## **NUCLEAR REGULATORY COMMISSION**

Title: Advisory Committee on Reactor Safeguards  
(ACRS) NuScale Subcommittee,  
Open Session

Date: Wednesday, November 20, 2019

**Figure 2.3-1: Limiting Analytical Distance to EAB and LPZ Outer Boundary**

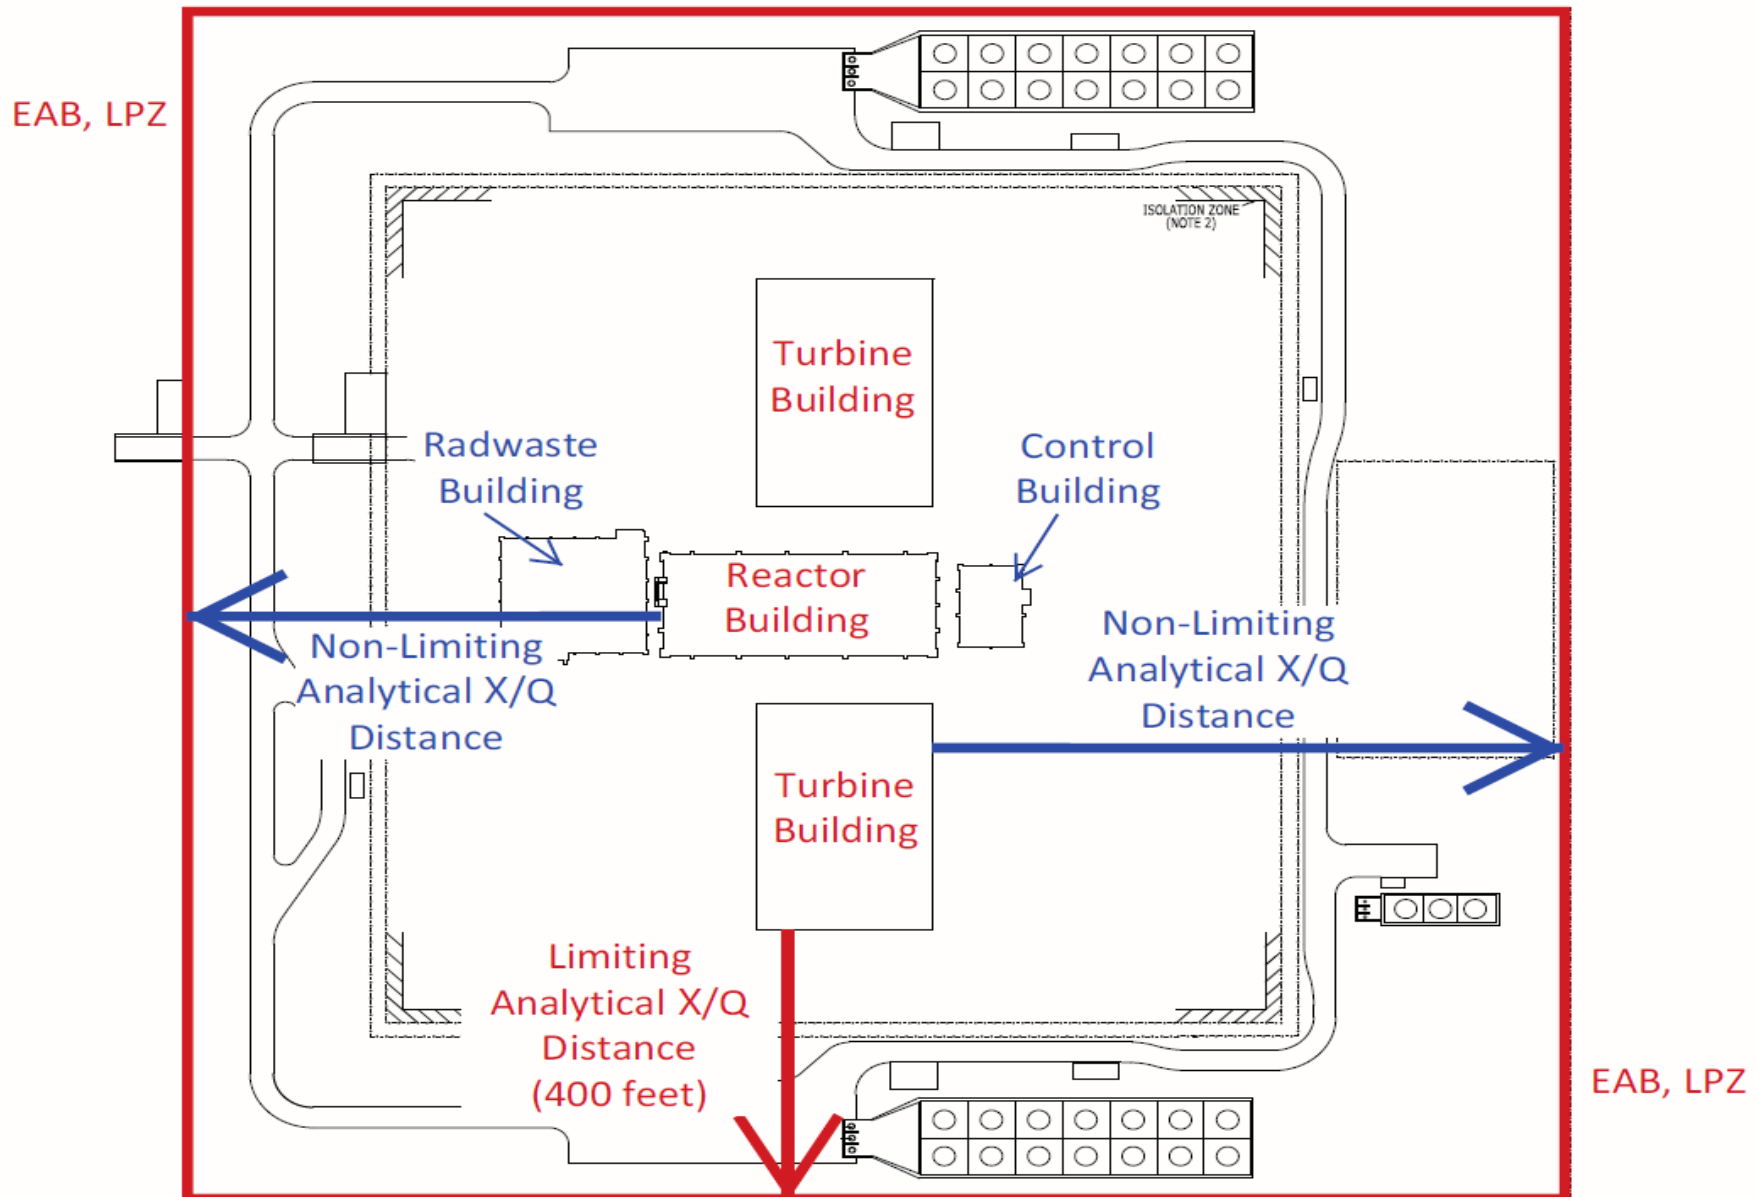
4                   NuScale states that ARCON96 computer code,  
5                   which is developed to model shorter distances, is more  
6                   appropriate for modeling NuScale EAB and LPZ chi over  
7                   q values. Thus, NuScale plans to use this version of  
8                   ARCON 96, NARCON, instead of PAVAN to calculate the  
9                   EAB and LPZ chi over q values.

10              MR. WHITE: So, yes, to answer your  
11       question there is a distance, and I'm looking for the  
12       number if you'd give me one moment. I think in the  
13       documentation for the ARCON96, there is an  
14       approximation where the developer of the code  
15       approximates that it's possible to use ARCON96 out to  
16       distances.

3 MR. WHITE: PAVAN is an acceptable method  
4 for the atmospheric dispersion calculations that  
5 belong to distance. If they decide to use an  
6 alternative method, they would have to provide a  
7 justification.
